Re: **Joliet Junior College, Illinois Community College District No. 525
Master Facilities Plan Phase 2, Automotive Building Expansion Work Bid Release 17
1215 Houbolt Road, Joliet, Illinois 60431**

Subject: **Supplement No. 2**

DIVISION 0 – REVISIONS, CLARIFICATIONS, AND MODIFICATIONS
SECTION 009113 – ADDENDUM 1

Subject: **Addendum No. 1 to the Bid Documents for:
Joliet Junior College - Automotive Service Technology Expansion
1215 Houbolt Road
Joliet, IL 60431**

ASK-1-1

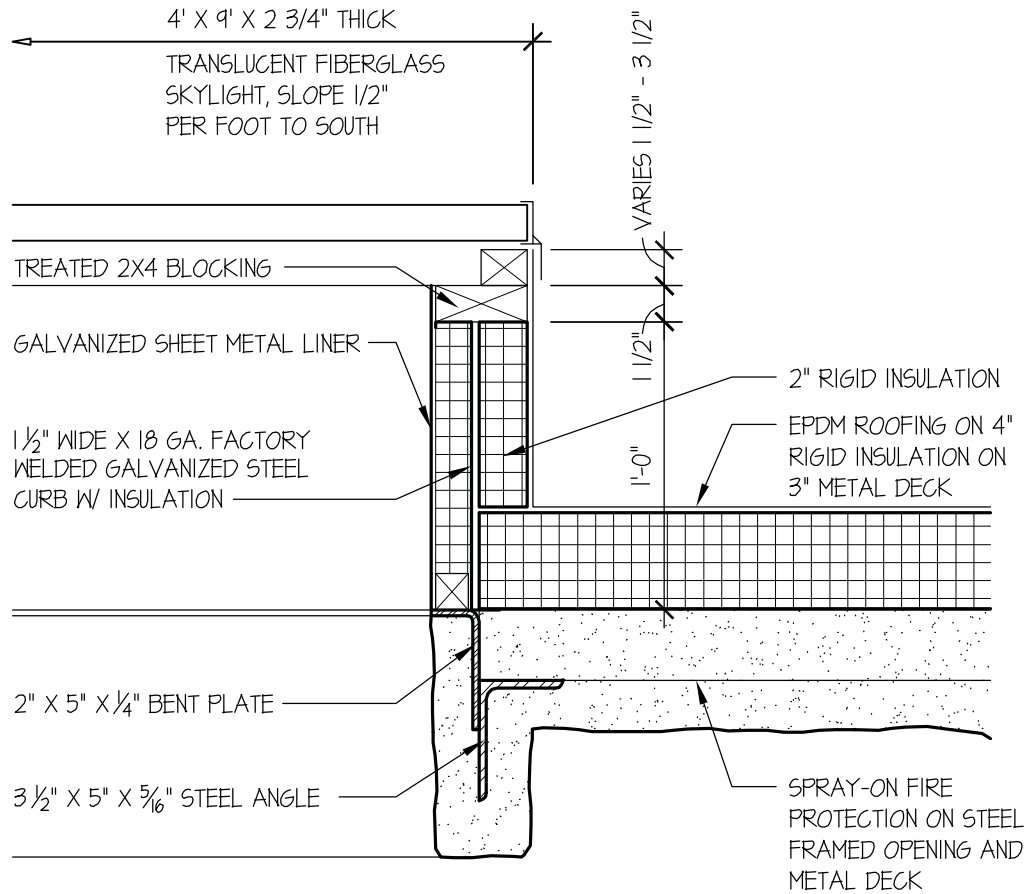
1. Drawing D2.01, Keynote 5: Note revised to include electrical work and piping attached to fence. Refer to sketch ASK-1-1.
2. Drawing A2.01: For clarification, be advised that this project includes no expansion joint assemblies in any floors.

- 5 REMOVE ALL CHAIN LINK FENCING, GATE, CONNECTIONS, FENCE POSTS AND ELECTRICAL WORK/PIPING ATTACHED TO FENCE. PREP FLOOR FOR PATCHING AT POST LOCATIONS.

ASK-M-01

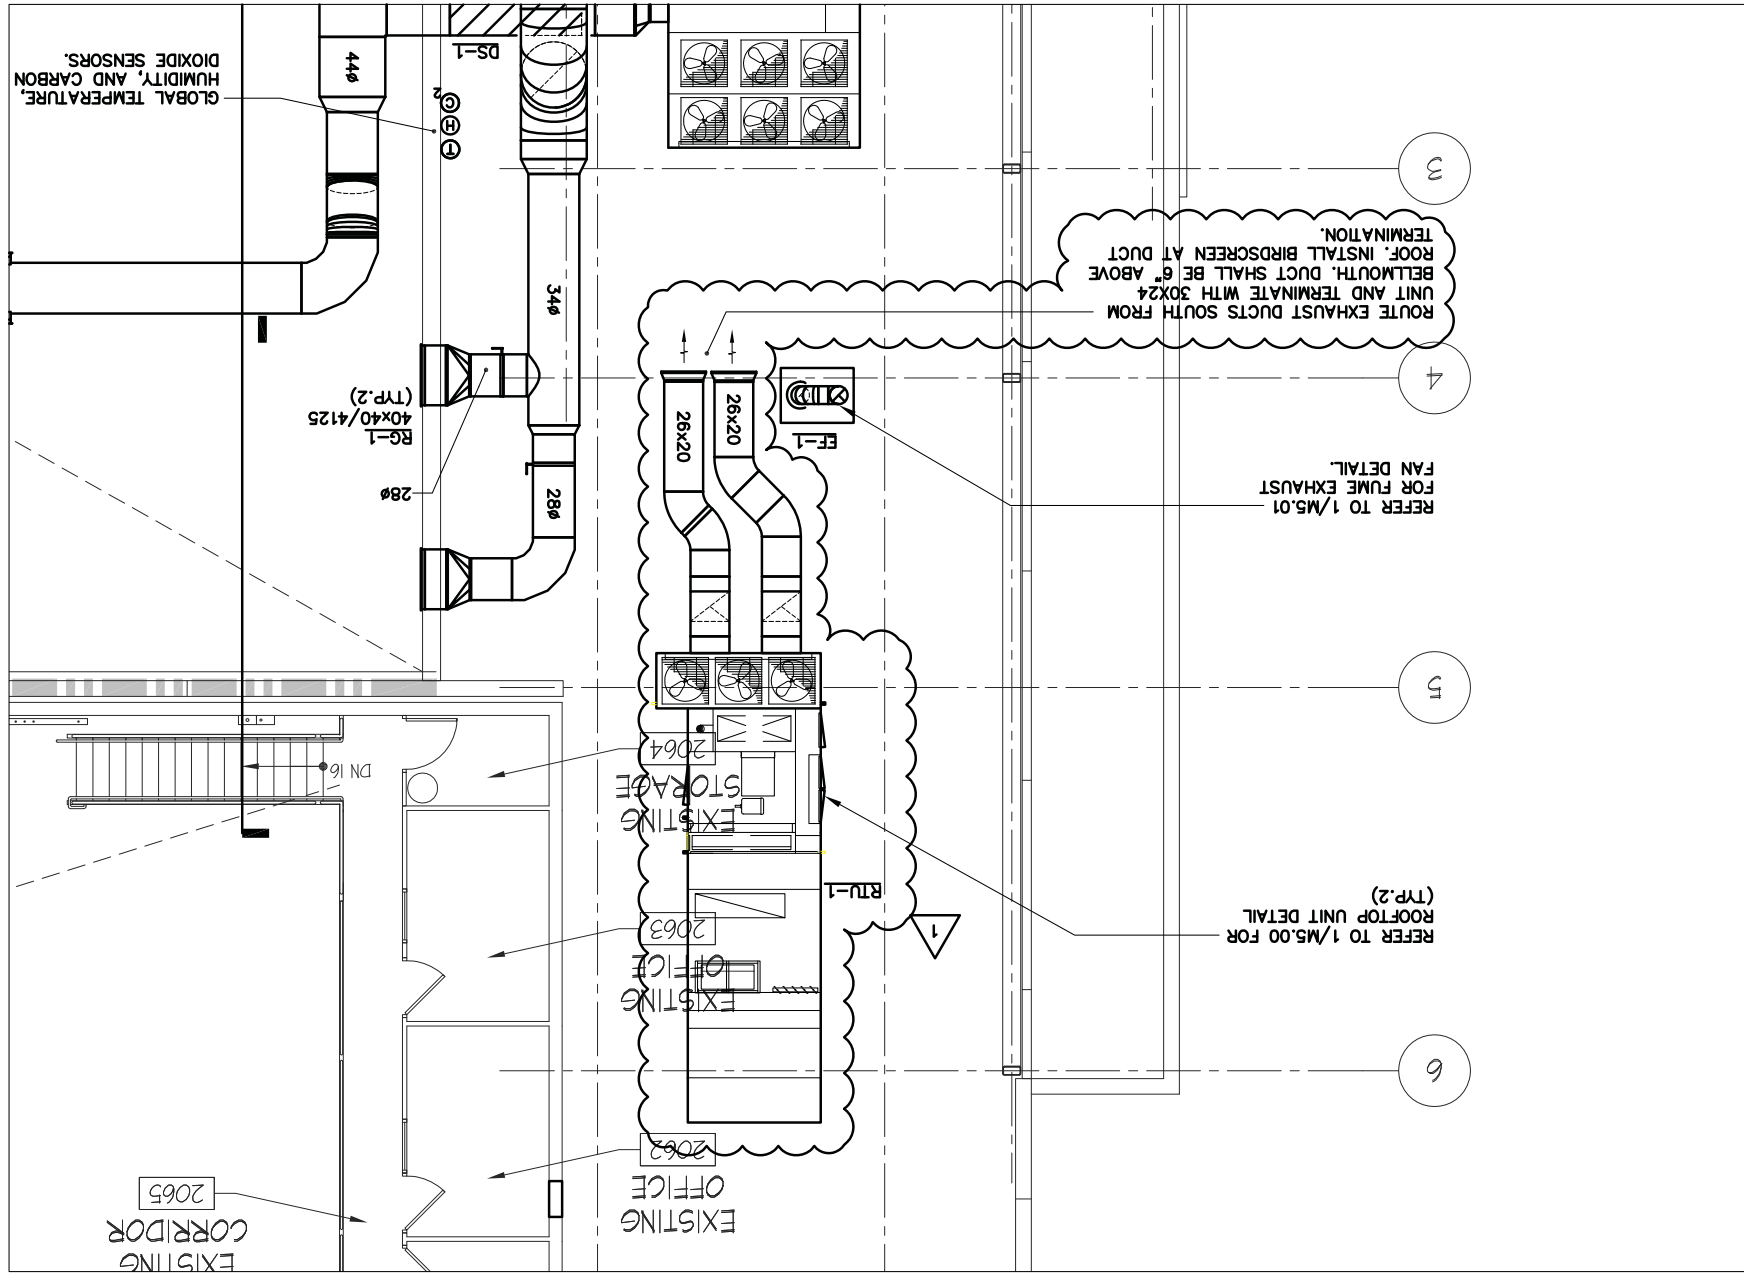
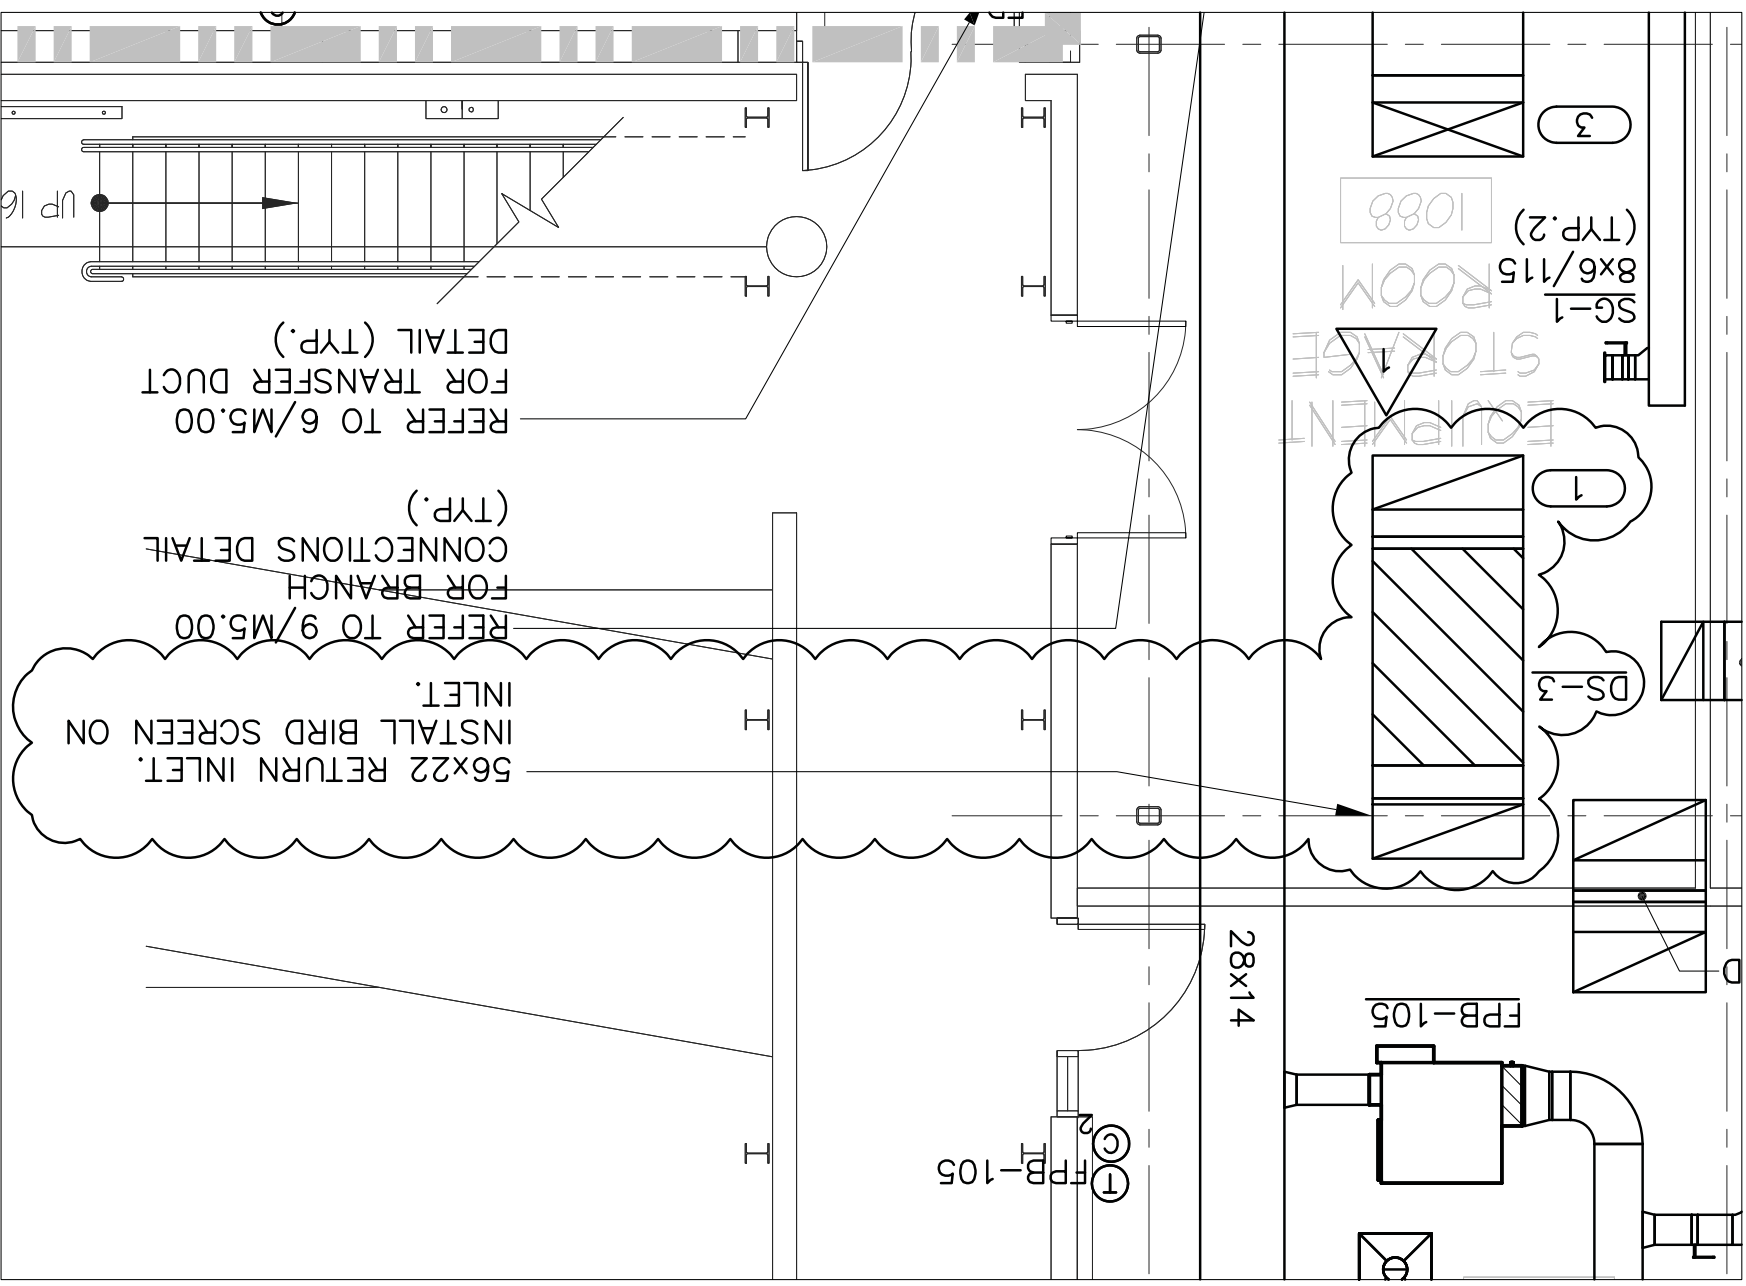
14. Drawing M5.00, Detail 8: In conformance with the specifications, as referenced in this detail, fully encase all under-floor ducts, fittings and branches in a minimum of 3" of concrete.
15. Revise roof top unit RTU-1 layout and footprint. Add exhaust ductwork routing from RTU-1 exhaust south on roof. Refer to Sketch ASK-M-01.
16. Revise roof top unit RTU-1 layout and footprint. Add exhaust ductwork routing from RTU-1 exhaust south on roof. Refer to Sketch ASK-M-01.
17. Revise return ductwork to match new RTU-1 footprint. Refer to Sketch ASK-M-02.
18. Revise 1/M5.00 rooftop unit detail. Refer to Sketch ASK-M-03.

ASK-E-01

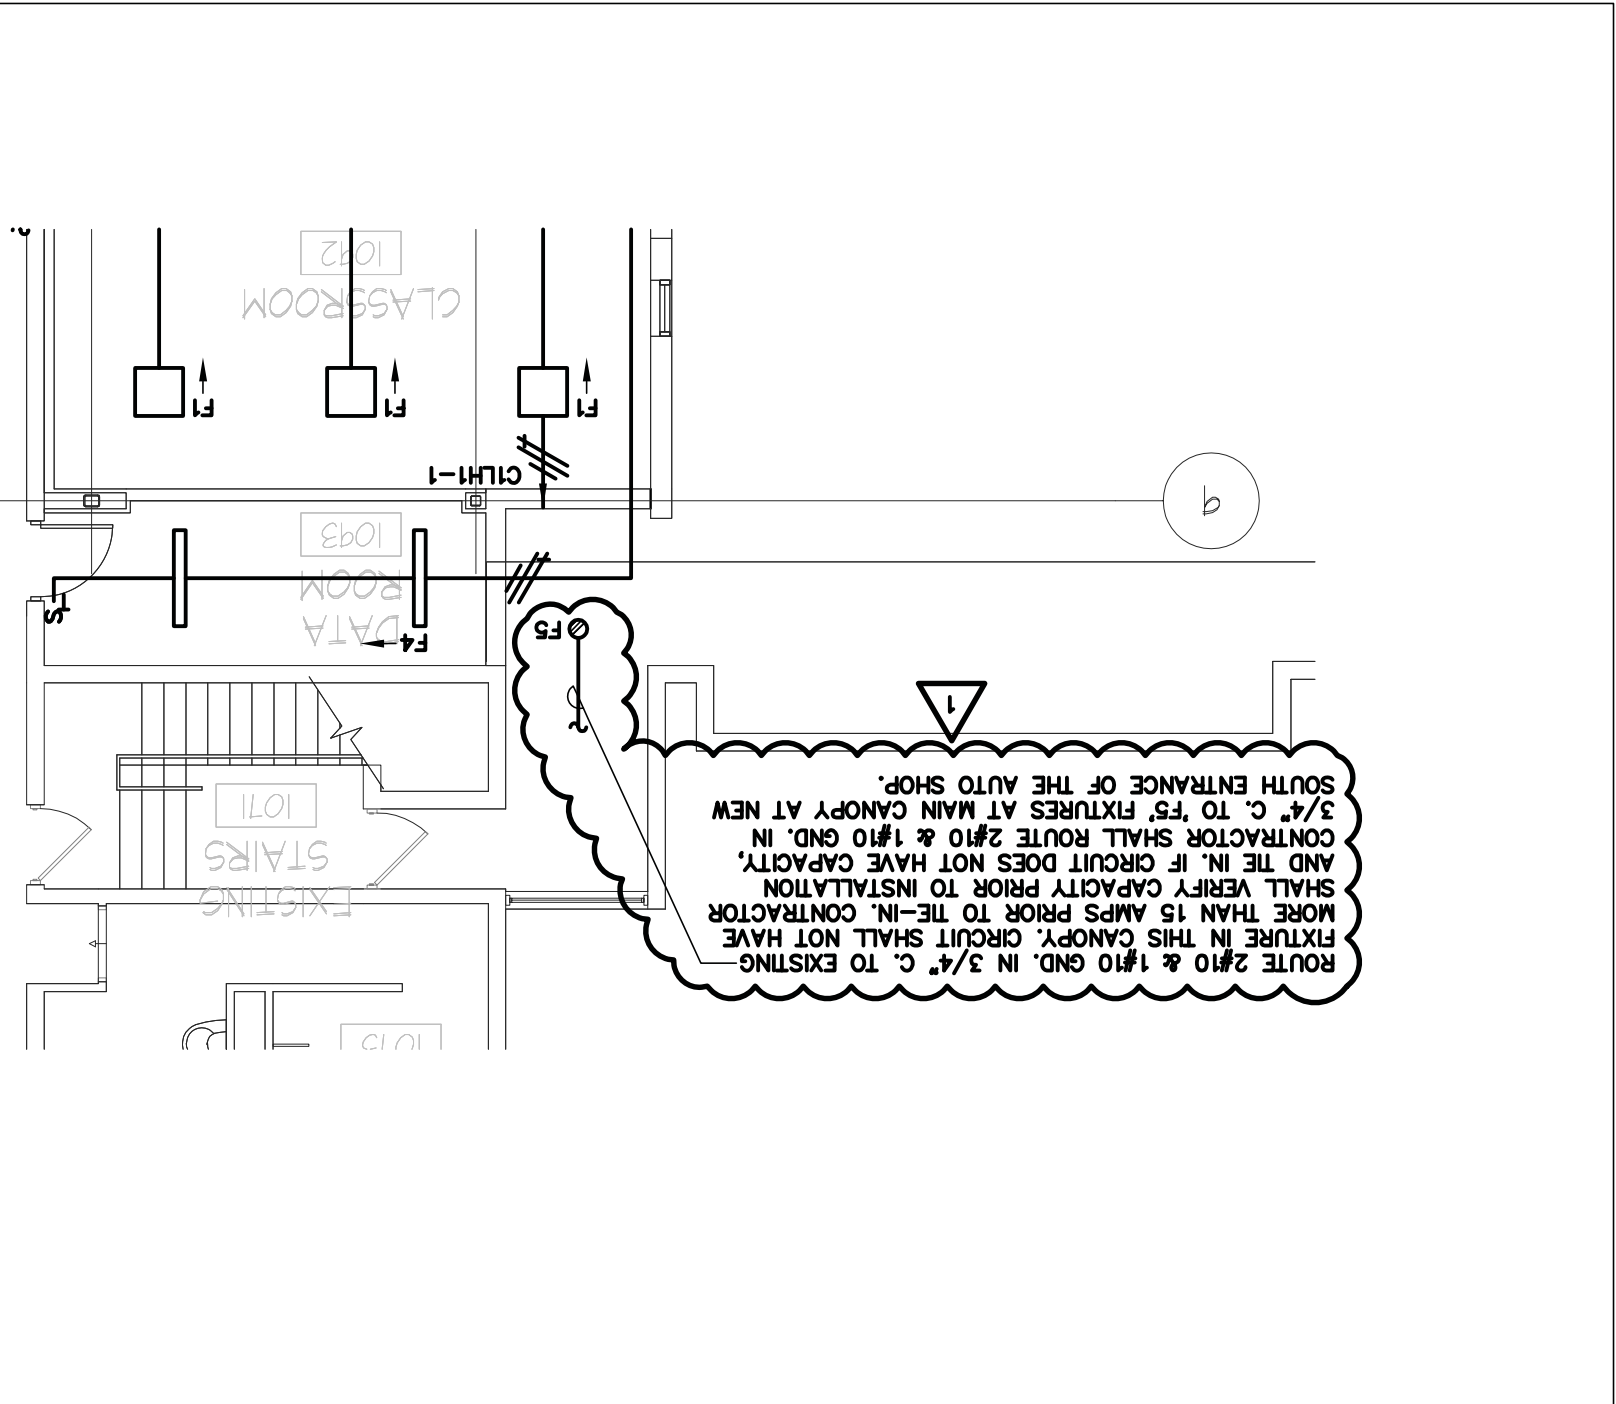
19. Specifications Section 23 72 00, Section 2.21, A: Add "Venmar" as an acceptable manufacturer.
20. Drawing E2.01: Add one (1) F5 luminaire in canopy outside of existing stair (1071). Refer to Sketch ASK-E-01 for luminaire location and circuiting requirements.
21. Drawing E6.00: Revise modification required for load interrupting switch serving DTR-'AS'. Refer to Sketch ASK-E-02 for load interrupting switch requirements.
